IN THE MATTER of a submission pursuant to
Clause 6 of Schedule 1 of
the RMA in respect of the
**Private Plan Change 85 –
Mangawhai East**

SUBMISSION ON PRIVATE PLAN CHANGE 85 – MANGAWHAI EAST

Review of Private Plan Change 85 Regarding Stormwater through Windsor Way Lots 1-7

Project description: Stormwater Review

Figure 4: Inundation zone theorised for the proposal in 100 years (Coastal)

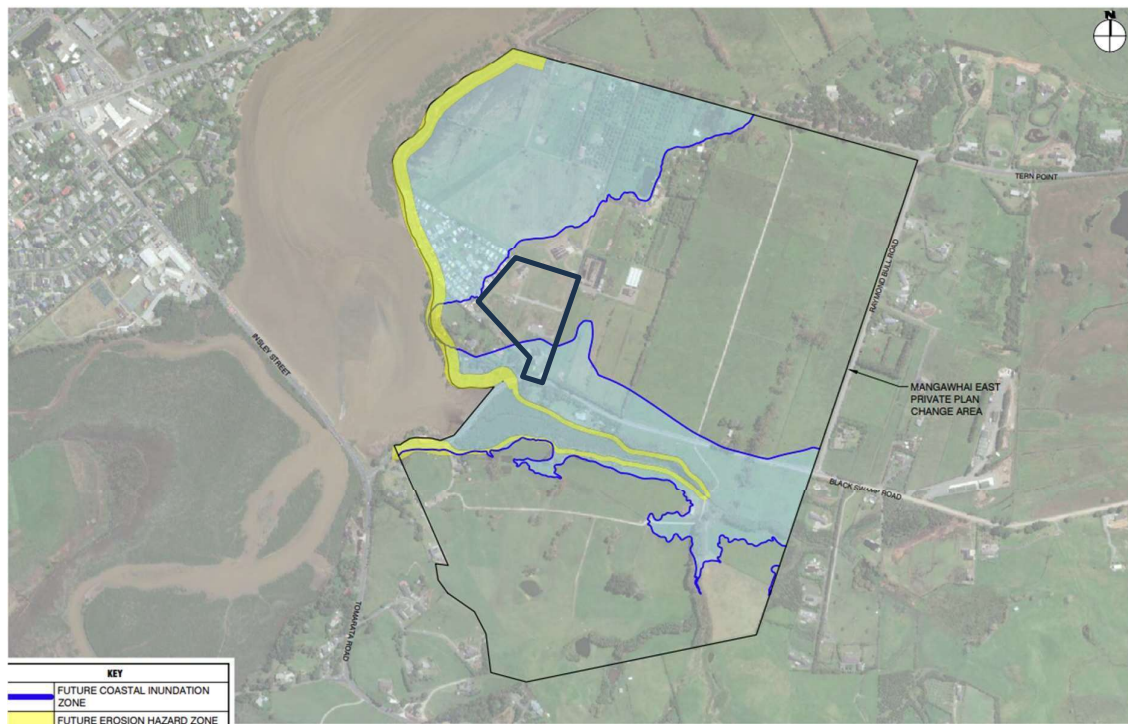
There is a predicted 100-year coastal inundation level (3.7 m RL) mentioned in the CABRAS report, which includes projections for sea level rise and vertical land movement. Lot 1 is located at the lowest point of the 7 lots (3.4 to 3.8 m). While the site is not currently affected by coastal erosion, Lot 1 is expected to fall within the inundation zone under 100-year + climate change scenarios.

Figure 5: Non proposed filling of the development to be 200mm above 100 year coastal innundation level

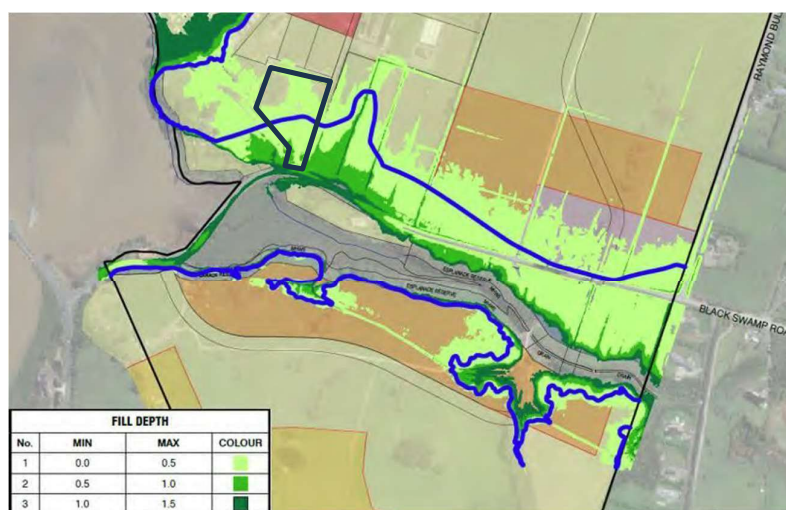
The CABRAS report includes a plan showing a potential ground level increase of approximately 200 mm above the 100-year coastal inundation level (RL 3.7 m NZVD2016). This fill concept is clearly marked as “not proposed” and is not discussed further in the report or included in the stormwater management strategy. No supporting modelling or design detail accompanies the plan.

Commentary:

Although not formally proposed, the presence of this fill plan in the documentation suggests it may be reconsidered at a later stage. Given the site's already flat topography, even small increases in ground level may worsen surface drainage and exacerbate localised ponding.

Introducing fill without a coordinated grading and conveyance strategy can lead to:

- Reduced fall across the site, making an already flat site effectively flatter;
- Entrapment of surface runoff in low areas or around fill transitions;
- Increased reliance on swales or overland flow paths, which must be carefully graded to avoid backfall or stagnation;
- Disruption of existing or proposed drainage patterns, especially if design across property boundaries is not coordinated.
- Cause ongoing long-term creep settlement where fill is over peat.

If this fill concept is revisited in future stages, it is strongly recommended that it be supported by:

- Site-specific drainage and overland flow modelling;
- Clear demonstration that fill will not isolate parts of the site hydraulically;

- Design solutions that preserve or improve drainage continuity toward the proposed discharge zones.
- Detailed geotechnical reporting on how to mitigate ongoing creep settlements due to fill material.

While raising building platforms may be desirable for resilience to coastal inundation, filling should not proceed in isolation from a complete stormwater design. In a flat site context like Windsor Way, even minor changes in surface level can materially alter where water collects and how it moves, potentially making existing issues worse rather than better.
